CHARGER

BATTERY CONNECTOR

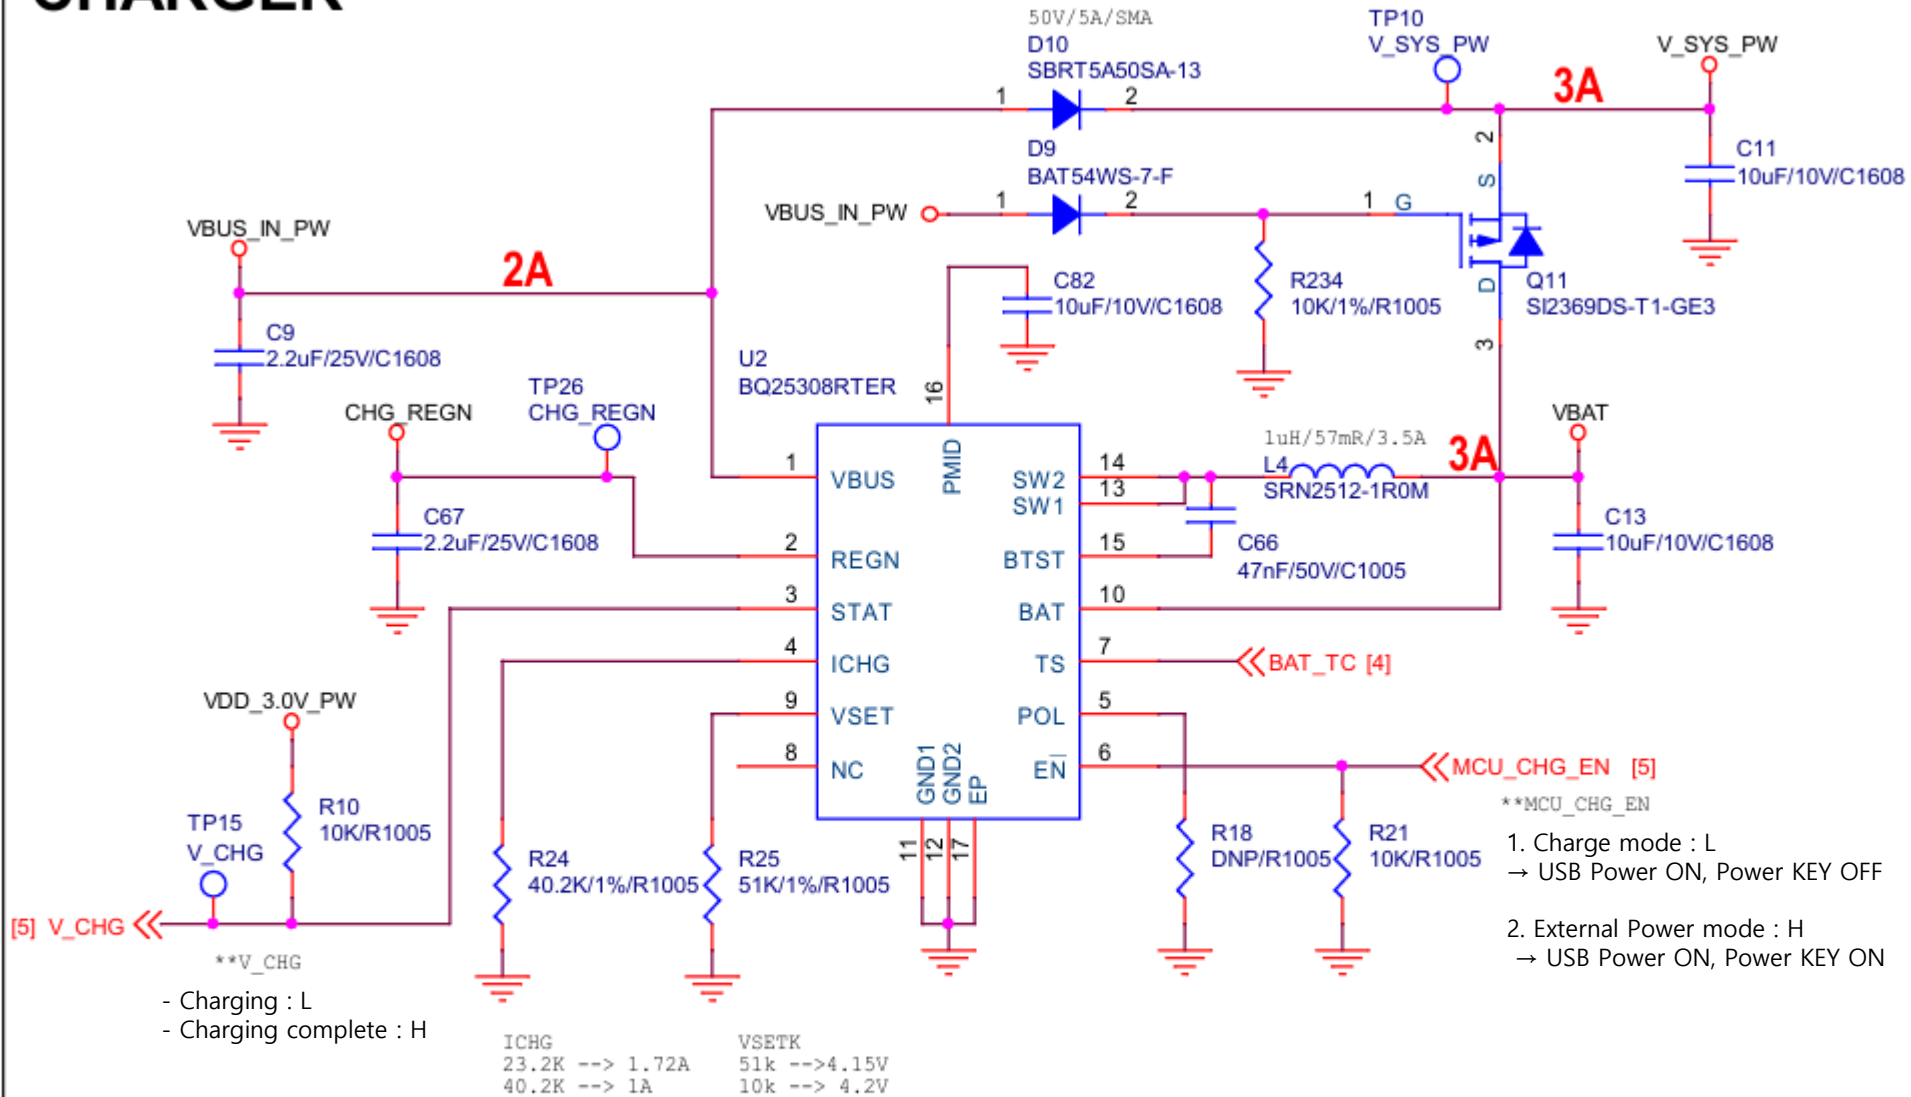
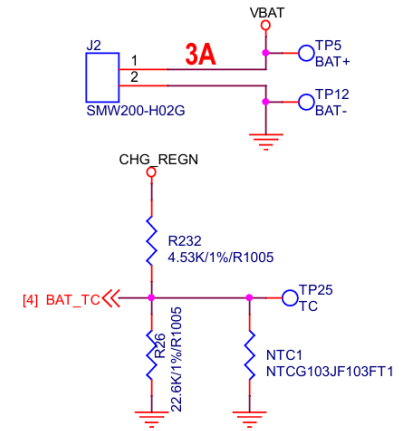
I see there was a change to include the addition of power path to the final schematic.

While figure 9-7 in the datasheet shows this use case, we are in the process of trying to remove this.

Connecting a powerpath to PMID pin is not recommended on this device.
Instead it is recommended to connect VSYS to VBUS and add an external reverse blocking FET.

The newest schematic does not show resistor selection at TS, so I cannot verify whether it is acceptable.

As clarification since POL pin has been connected to GND /EN pin will need to be pulled to logic high to enable charging with the BQ25308

-> Add reverse diode (50V / 5A / SMA)

-> Add NTC circuit

-> DNP applied

MOTOR/SOL POWER

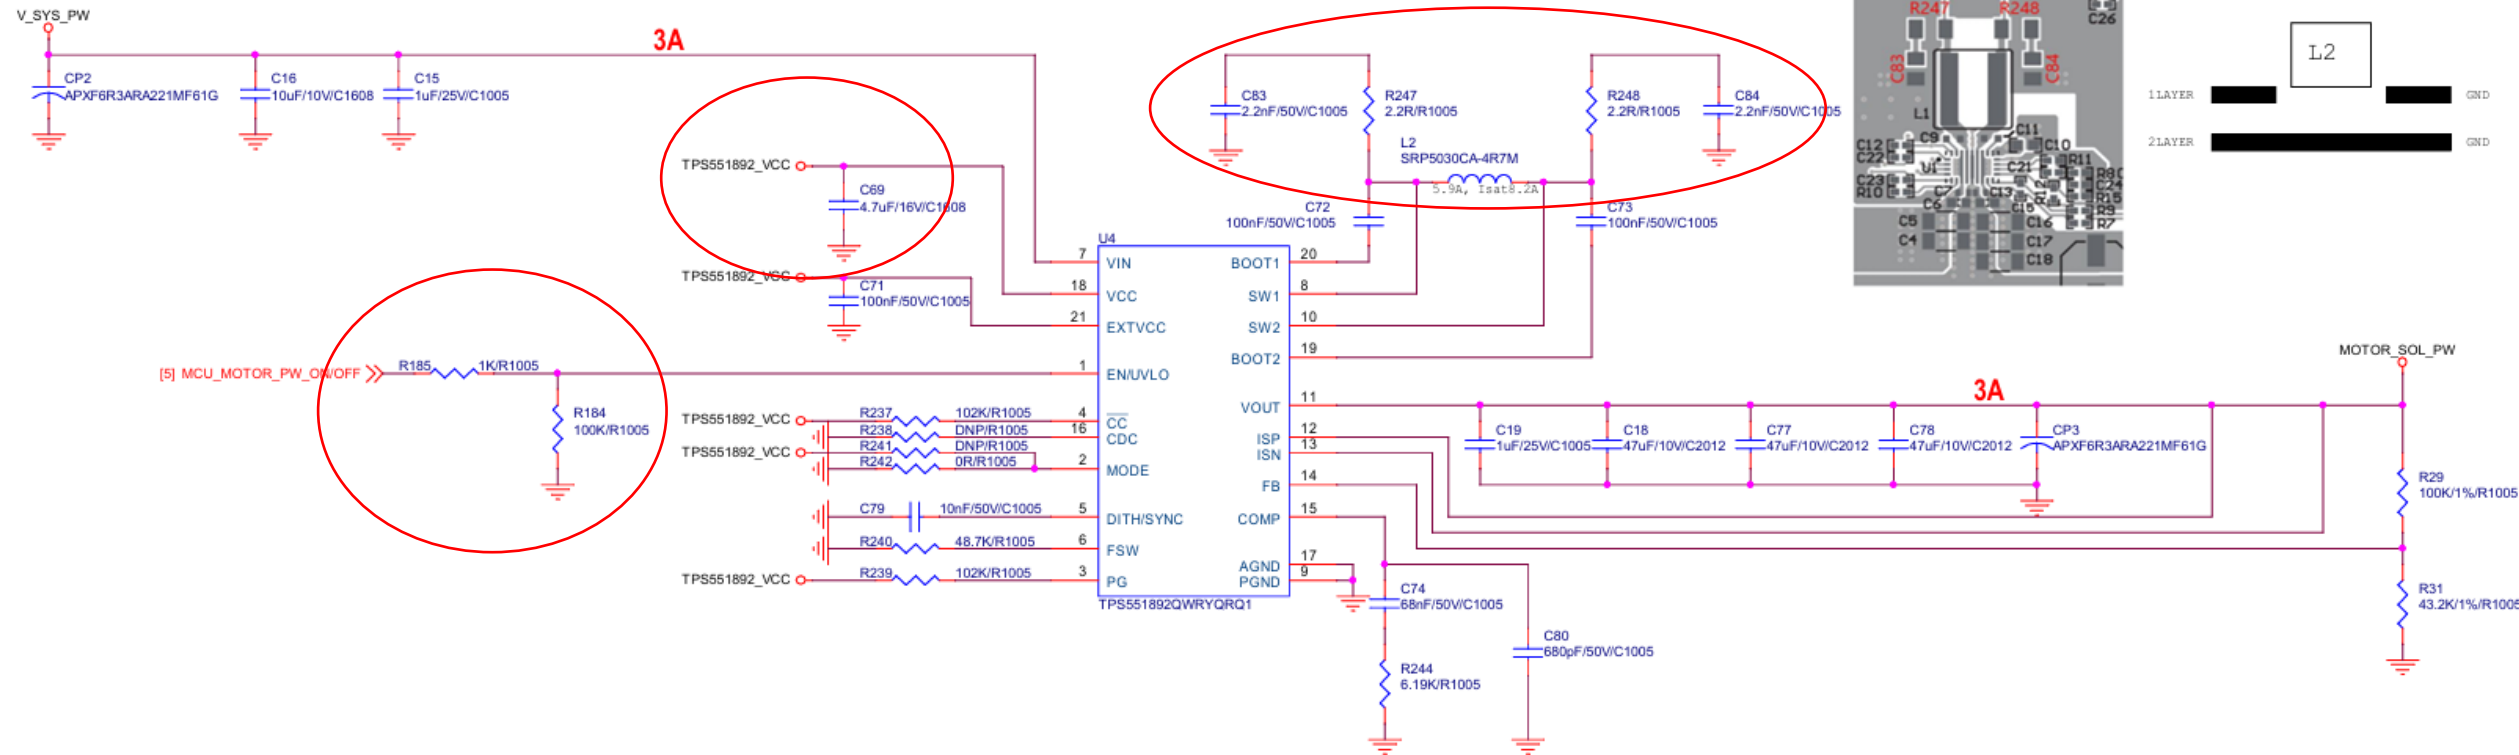
-If the MCU_MOTOR_PW_ON/OFF signal is higher than 1.23V, customer can directly use this signal to enable EN pin. Just add a 100kohm pull down resistor.

- Change C69 to 16V rated to ensure 2uF effective capacitance with DC derating.

- Change L2 to 4.7uH with 8A Isat

- Recommend to reserve RC snubber in SW1 and SW2

-If customer doesn't use the output current limit function, remove R245 and directly connect ISN and ISP to Vout.

→ Since the MCU output voltage is 3V, delete the existing circuit and connect the MCU directly.

→ C69: 4.7uF voltage change from 10V to 16V

→ 4.7uH/rated 5.9A/Isat 8.2A, SRP5030CA-4R7M change

→ Add RC snubber circuit

-->Short after deleting R245
